Technical Bulletin

26 19 02 April 24, 2019 **2028415** Supersedes Technical Bulletin 26-17-02 dated October 10, 2017 to update warranty labor operation number due to SAGA changes.

MIL ON, Secondary Air DTCs P2431, P2432, P2433 Stored in ECM Fault Memory

- Install sensor Service-kit Part Number: 07K 198 125.

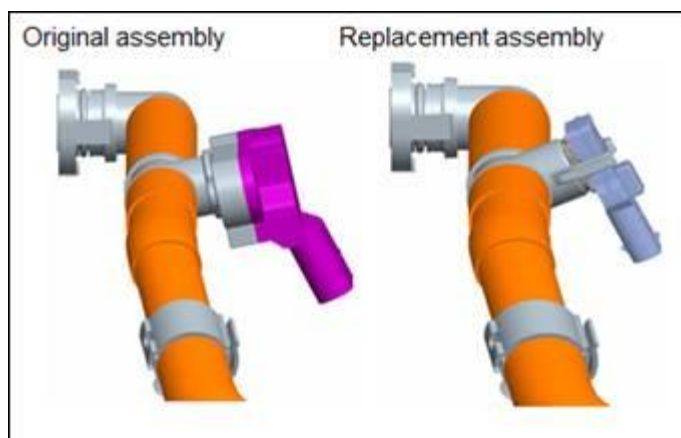
Original components were manufactured as an assembly (hose with sensor).

Updated sensor can be serviced separately from hose, see ETKA under part number **07K 906 051 ***.

Service-kit uses a different sensor and connector.

An adapter harness is supplied with sensor Service-kit. It is to be connected between the vehicle harness and the new sensor.
